Request For Information Response for DA35/2024

1 GATACRE & 5 ALLISON AVENUES, LANE
COVE

GATACRE LC PTY LTD

Figure 1: Extracts of revised stormwater drainage system to connect into Haldane Crescent
Source: CSEG Group

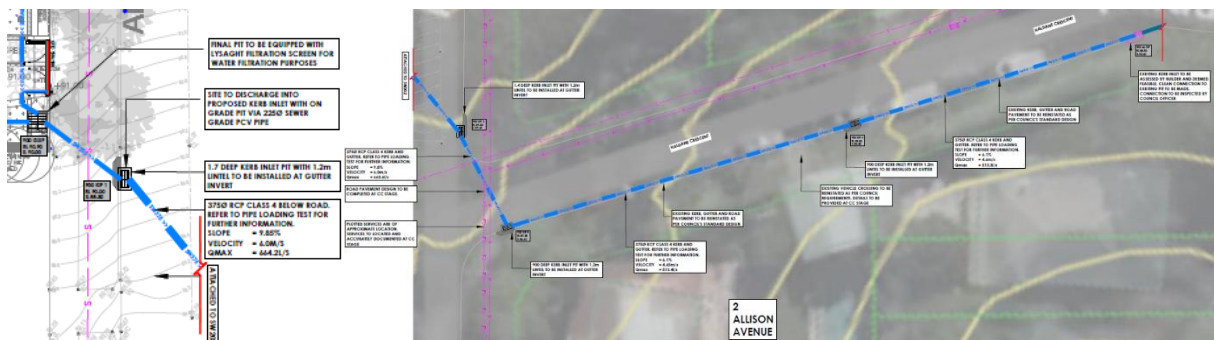
The stormwater management plan has a basement pump out system which would exacerbate seepage water and additional runoff from the driveway ramp. As a result, the pump would be required to work constantly to syphon water into the OSD tank.

The design shows that the OSD is directly connected to kerb line in Alison Avenue. This is not permitted as per section 5.4 of Council's stormwater DCP. The applicant must connect stormwater to the nearest inlet pit on Haldane Crescent by installing a new drainage system up to the site. Please see attached sketch at the end of this letter for proposed drainage extension in Attachment 'B'.

The proposed stormwater drainage system has been revised in line with Council's sketch (**Appendix 5**).

As shown in Figure 1, the system will connect in to the existing kerb inlet pit on Haldane Crescent via four (4) new kerb inlet pits that will be connected by 375mm stormwater pipes to the existing kerb inlet pit on Haldane Crescent.

Figure 2: Extracts of Upper Ground Floor Plan showing wall openings to eastern apartments and blank wall to south

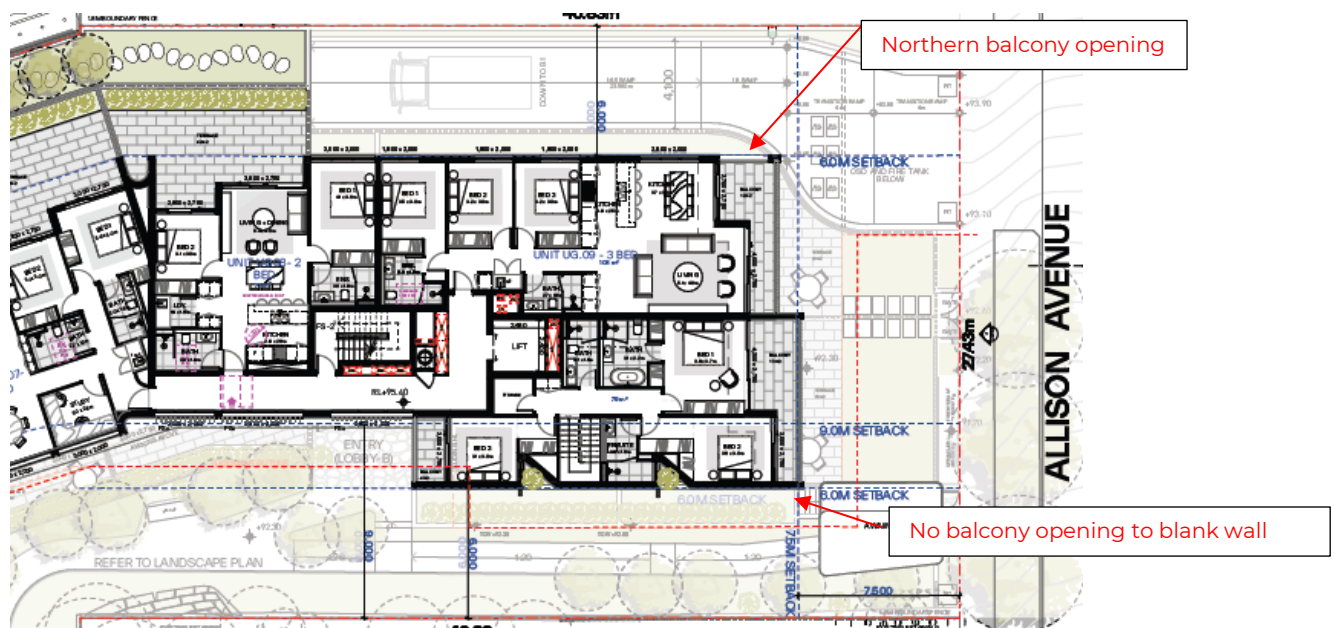
The southern elevation plan (DA200) appears to show openings on the front balconies on upper ground, level 1 and level 2 facing 7 Allison Avenue. See red outline notation on elevation below, and Level 1 plan which has no associated openings on the south facing wall. Given that the building setbacks from this boundary are at 6m, this wall should be non-habitable and feature no windows/openings.

The openings identified are to the balcony walls of apartments UG09, 109 and 209 and are on the northern edge of the building adjacent to the driveway. There are no balcony openings to the south facing wall, as shown in Figure 2.
